Three Mile Island Nuclear Station, Unit 1  
Renewed Facility Operating License No. DPR-50  
NRC Docket No. 50-289

Subject: Third Six-Month Status Report in Response to March 12, 2012 Commission Order  
Modifying Licenses with Regard to Reliable Spent Fuel Pool Instrumentation (Order  
Number EA-12-051)

**Third Six-Month Status Report for the Implementation of Order EA-12-051, Order  
Modifying Licenses with Regard to Reliable Spent Fuel Pool Instrumentation**

# ATTACHMENT 1 - TMI-1 SPENT FUEL POOL ELEVATION SKETCH

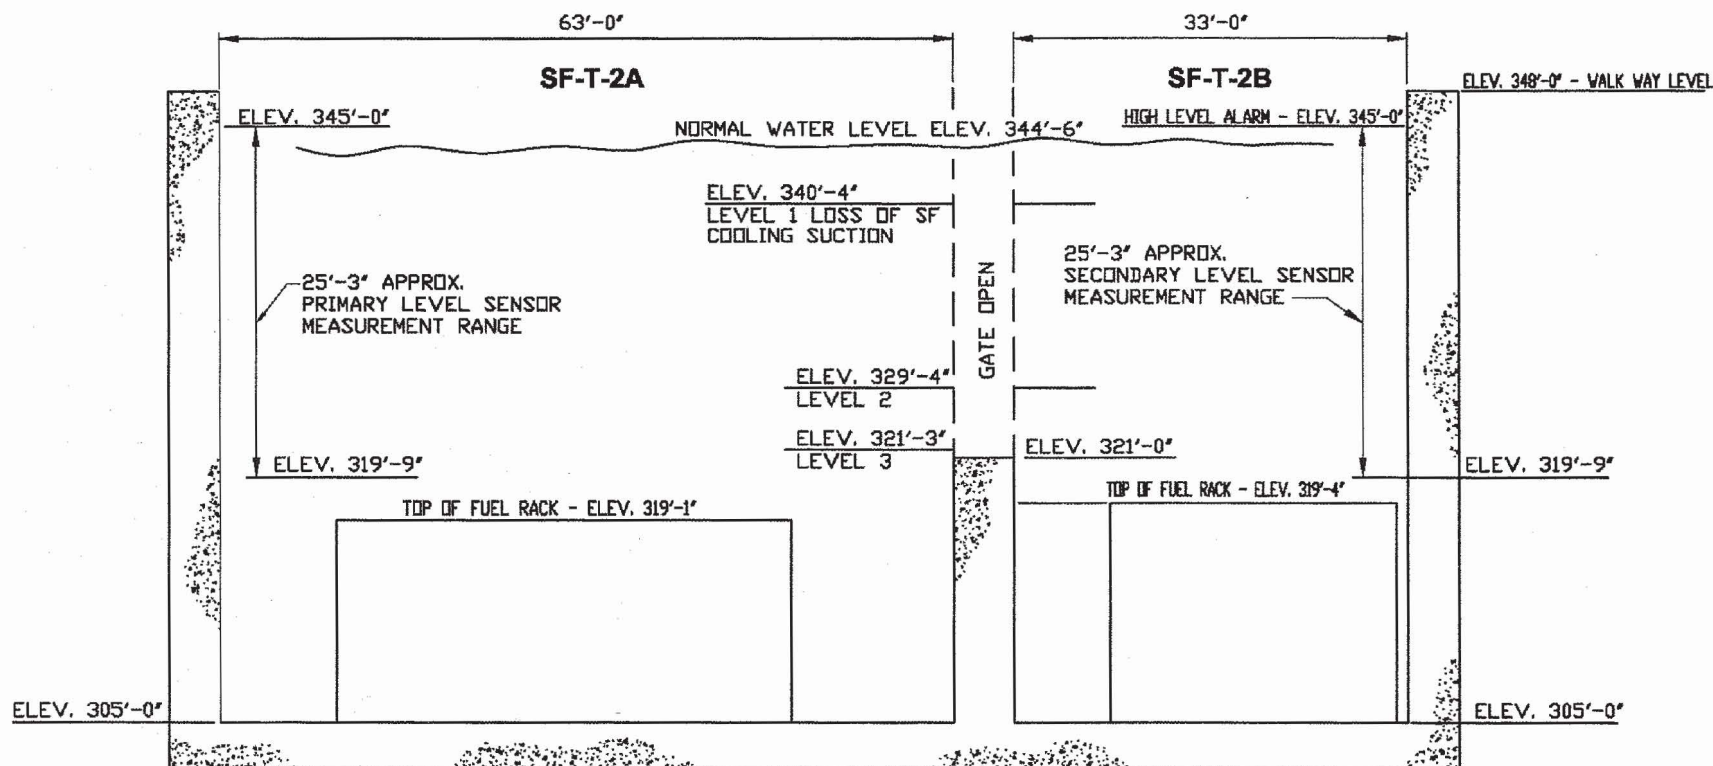
Draft Safety Evaluation Open Items		
OI#	Description	Status
1 (RAI-2 Ref 5)	<p><u>RAI Question:</u>  <b>Please describe the impact of the installation of the gate on the reliability of the SFP level instrumentation for each SFP, and what compensatory measures would be taken to ensure reliable level indication in each SFP when the gate is installed.</b></p>	<p><u>Complete</u>            Complete redundant monitoring of the pools will not be available when the gate is installed. The gate is not normally installed. There is an existing procedure 1507-2, Fuel Handling Building Crane Operations, which installs and removes the gate. To address the concern when the gate may be installed the procedure 1507-2 will be revised to establish administrative guidance/controls to follow the NEI 12-02 Rev. 1 section 4.3 guidance for the 90-day out of service criterion. Action will be tracked by AR evaluation A2322479-08. The elevation for the bottom of the gate opening for TMI is 321ft. Level 3 for TMI is revised to elevation 321ft. 3 in., which is slightly above the bottom of the gate opening, rather than, the top of the Fuel rack elevation 319ft. 1 in. This will provide assurance that both the primary and backup SFP level instrument channels can measure the same Level 3 elevation in both SFPs. See revised Attachment 1.</p>
